# UNITED STATES PATENT AND TRADEMARK OFFICE

APPLICATION NO.	FILING DATE	FIRST NAMED INVENTOR	ATTORNEY DOCKET NO.	CONFIRMATION NO.
09/516,655	03/01/2000	Thomas C. Thompson		3209

<b>Office Action Summary</b>	Application No. 09/516,655	Applicant(s) THOMPSON, THOMAS C.	
	Examiner Ernesto Garcia	Art Unit 3679

## DETAILED ACTION

**FIG. 10**

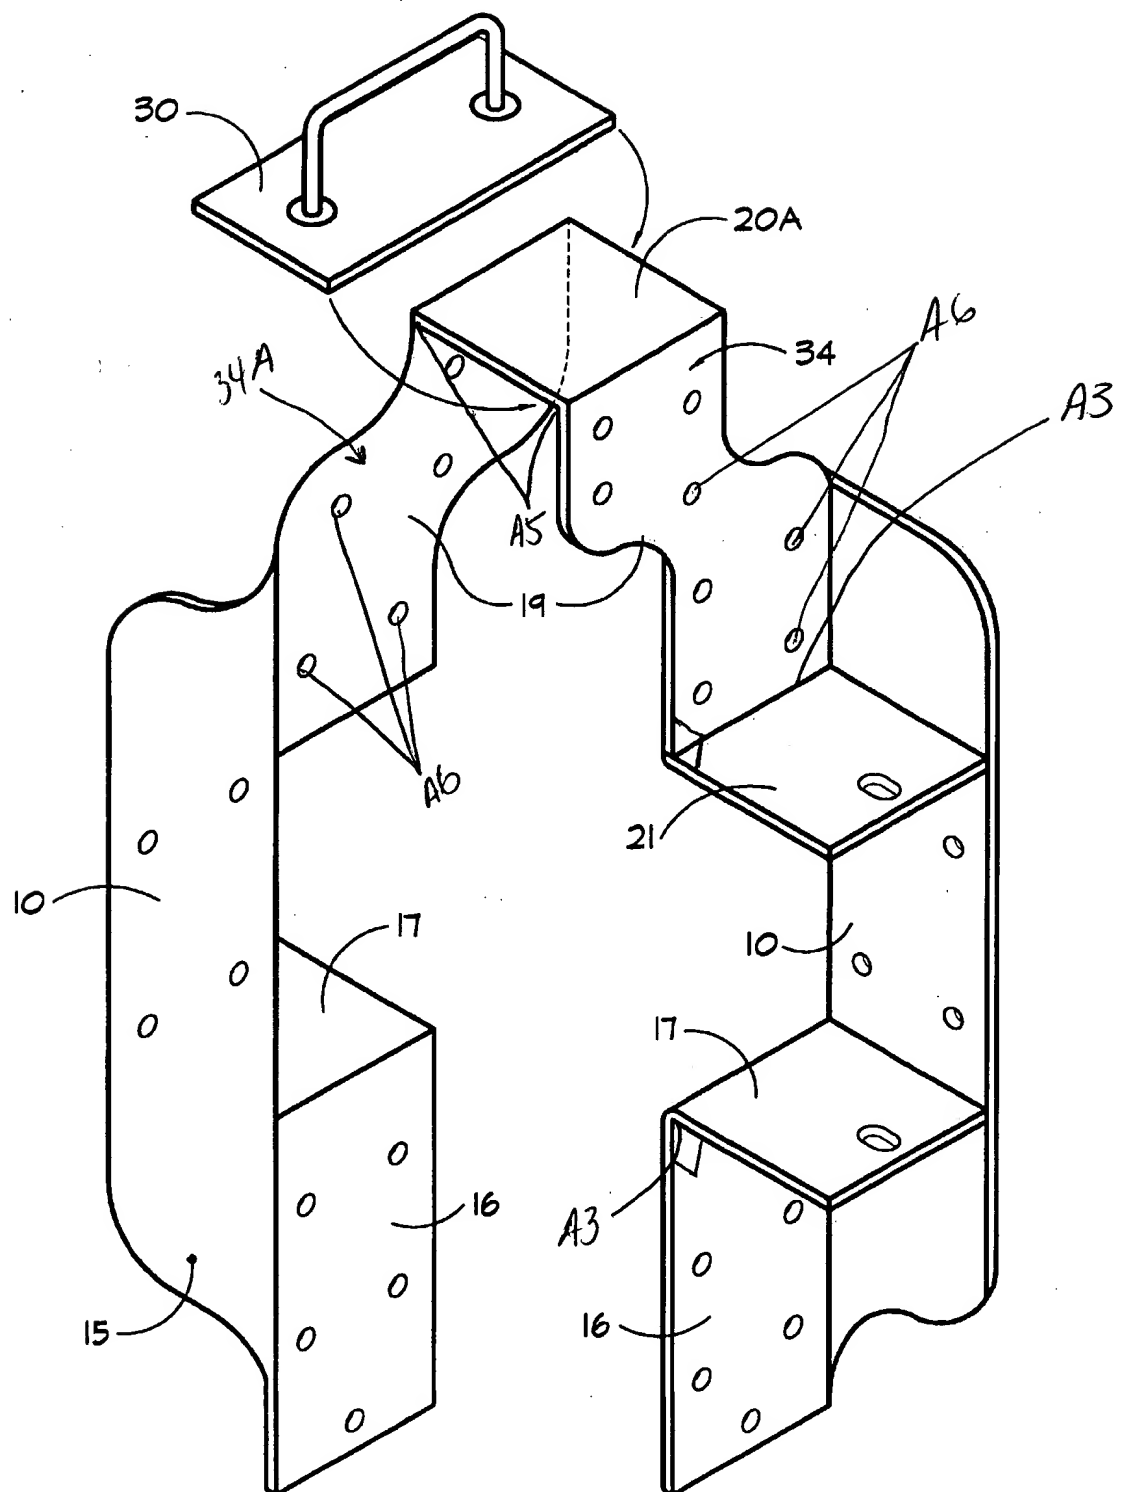
Regarding claim 1, Thompson discloses in Figure 10 a unitary connector comprising a base web **34A**, and an offset, angled, top web **34**. The top web **34** has generally right angle bends **A3** forming rafter webs. The base web **34A** and the top web **34** are connected by an offset web **20A**. The offset web **20A** has angled bends **A5** attached to the base web **34A** and the top web **34**.

Regarding claim 2, the base web **34A** has a generally flat, generally long-horizontal rectangular shape, and nail holes **A6**. Applicant is reminded that the holes **A6** are for retrofitting to the exterior wall, and into an underlying structural member.

Regarding claims 3, the offset web **20A** is attached to the base web **34A**.

Regarding claim 4, the offset web **20A** is attached to the top web **34**.
